STAFF RECOMMENDATION

1239 6th Avenue North

May 17, 2017

Application: Alterations; Demolition—addition; New construction—addition

Figure 2 shows the rear addition that will be demolished.

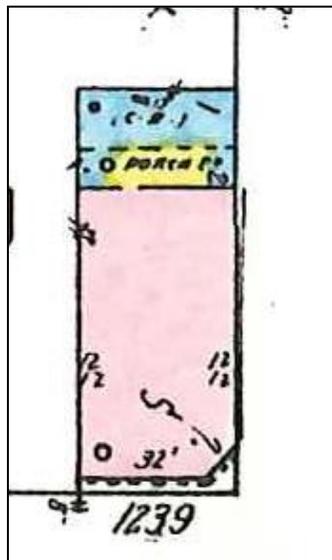
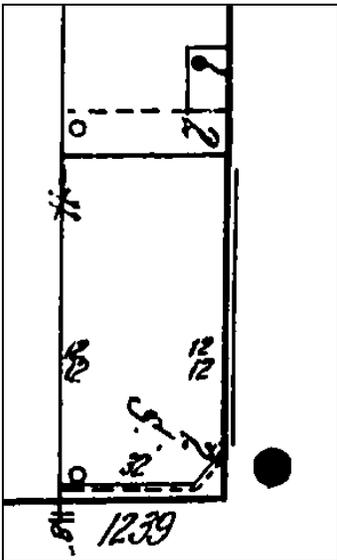
Demolition. The applicant is proposing to demolish the existing rear extension (Figure 2). The date of construction of the rear addition is not known, but the 1914 and 1957 Sanborn maps show that there were rear extensions to the structure historically, but their size and depth are different now than they were then (Figures 3 & 4). Staff finds that the rear extension's materials, form, roof slope, fenestration pattern, and date of construction do not contribute to the historic character of the historic commercial structure. Staff therefore finds that its removal meets Section 7.0 of the design guidelines.

Figure 3 (left) is the 1914 Sanborn Map. The rear extension is shown here as a two-story porch structure with a small one story addition. Figure 4 (right) is the 1957 Sanborn Map. Part of the addition is a two story porch, and the other part is a one-story concrete block structure.

L02

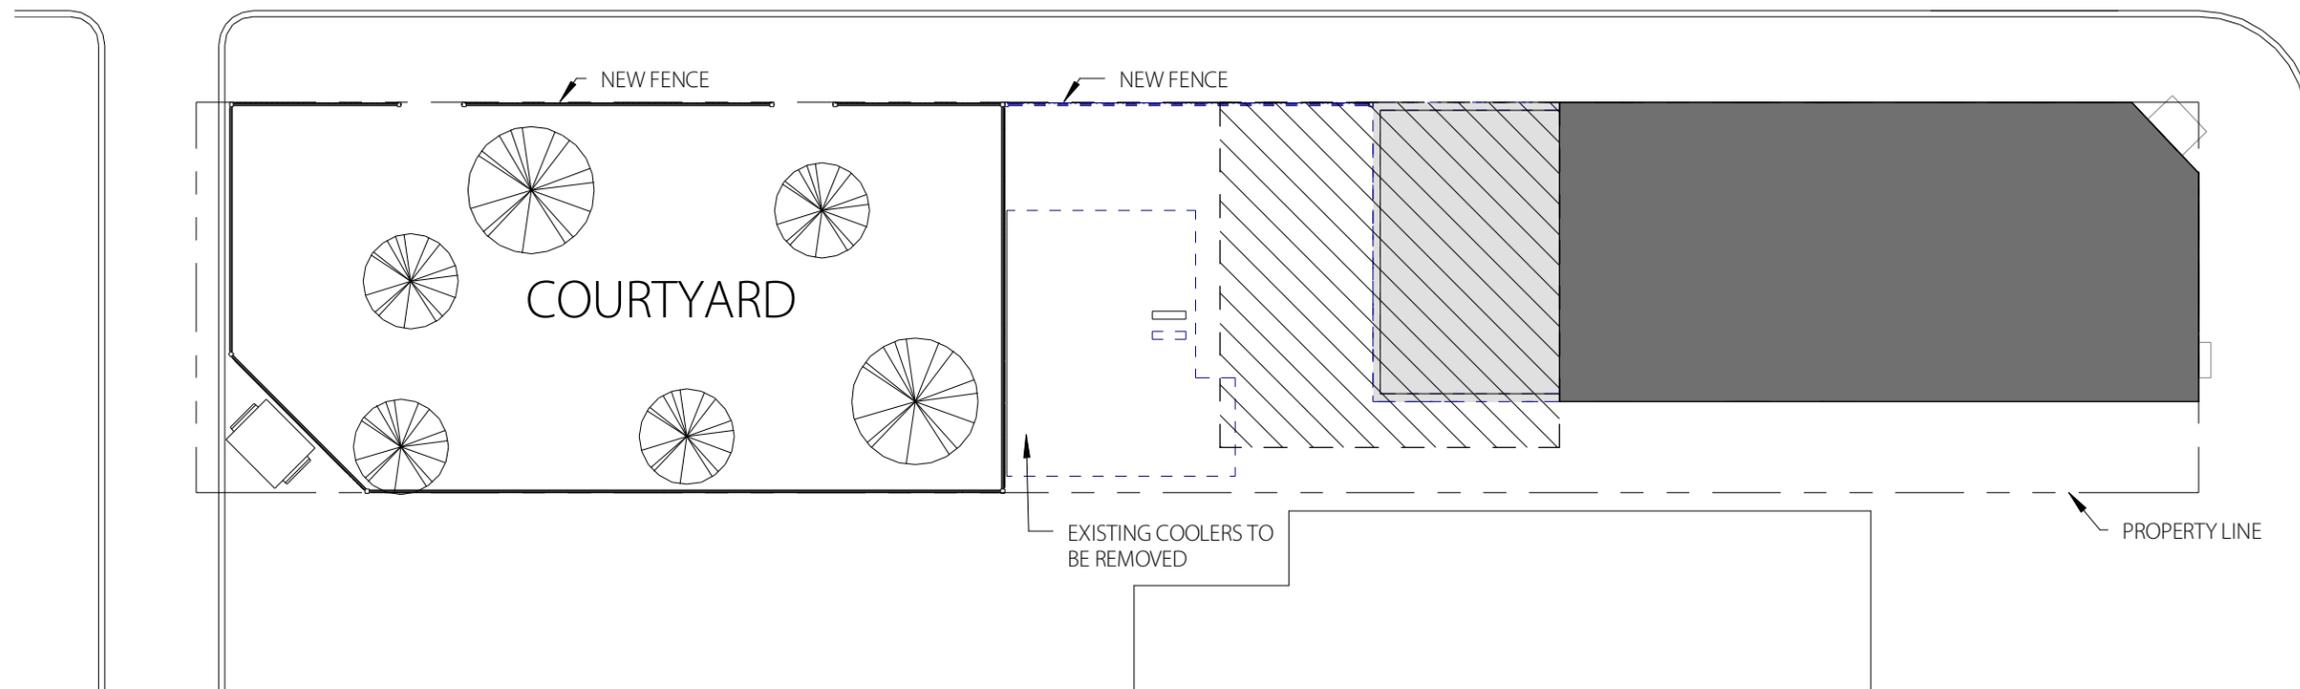
Permanent Landscape Features. The site plan indicates that the applicant intends to install a new fence and to create a courtyard at the rear of the property. All fencing and permit-landscape features, including, but not limited to, paving, lighting, trellises, etc, must be reviewed and approved by the Metro Historic Zoning Commission to ensure their compliance with Section 5.0 of the design guidelines.
